## Proposed Revisions to a Standard Plans Index

Date: April 15, 2021 Originator: Rick Jenkins Index Number: 425-061 Sheet Number (s): 2

Index Title: Closed Flume Inlet

TYPE-I DIMENSIONAL DETAILS

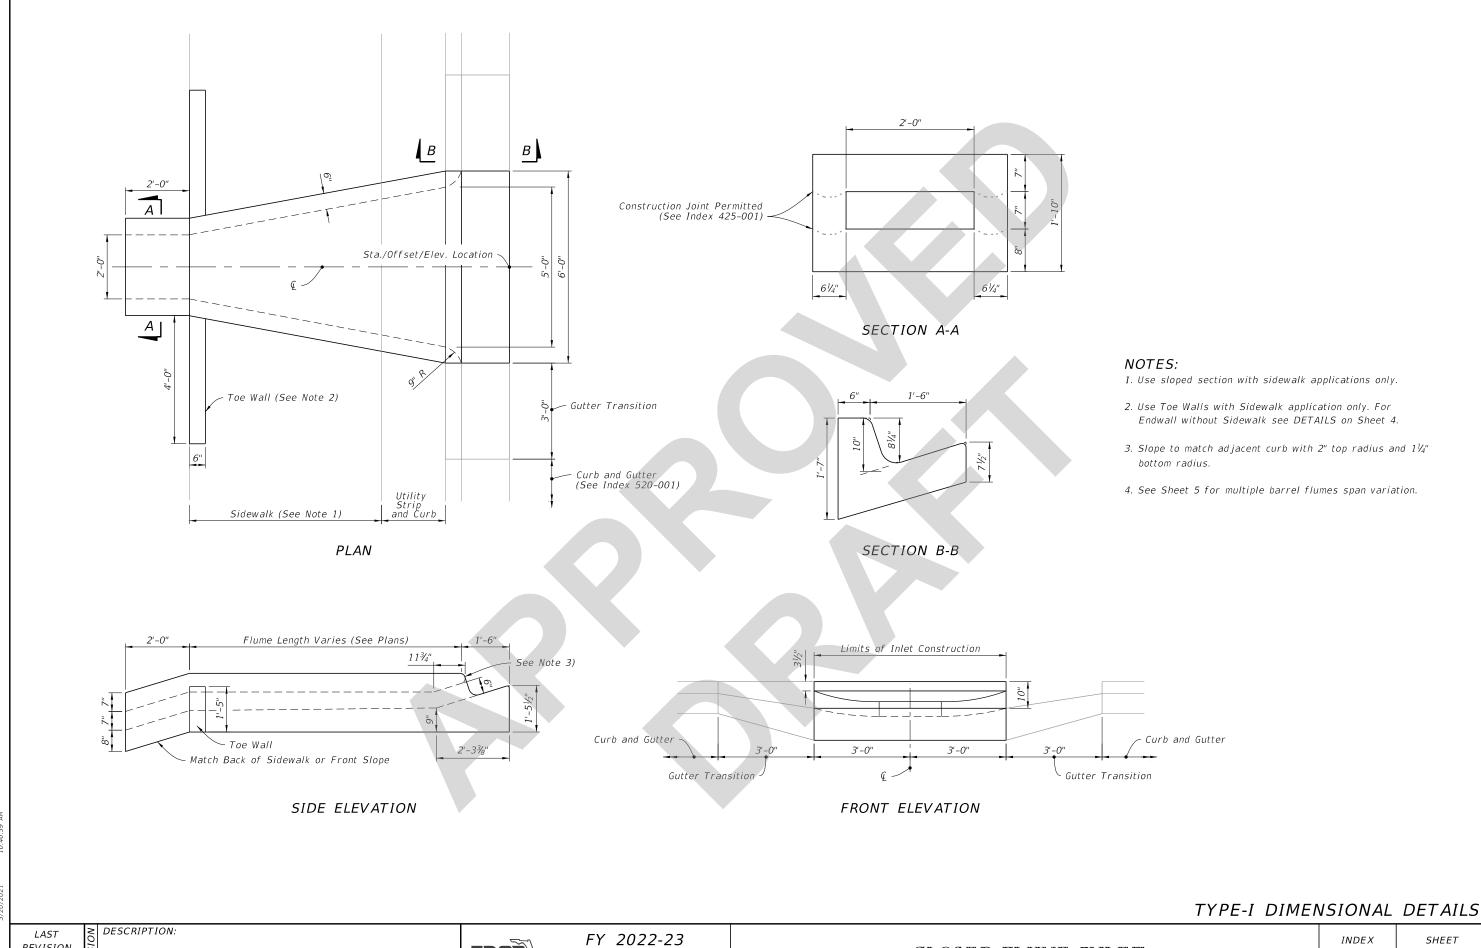
Revised dimension in Side Elevation detail to "Flume Length Varies (See Plans)". This also requires a change to the SPI. Deleted "Varies from 3' 1/2" to 6'-0" for single barrel flume." from note 4. Deleted "varies" from section A-A and Plan view.

Remove reference to Dimension "D" in SPI and change text in SPI and Index to "Flume Length" to allow for this to be called for in the Plans. The "varies" callouts were deleted from the section references and note because the sections as shown are not variable.

- 1. Use sloped section with sidewalk applications only.
- 2. Use Toe Walls with Sidewalk application only. For Endwall without Sidewalk see DETAILS on Sheet 4.
- 3. Slope to match adjacent curb with 2" top radius and  $1\frac{1}{4}$ "
- 4. <del>Varies from 3'-1/2" to 6'-0" for single barrel flume</del>. See Sheet 5 for multiple barrel flumes span variation.
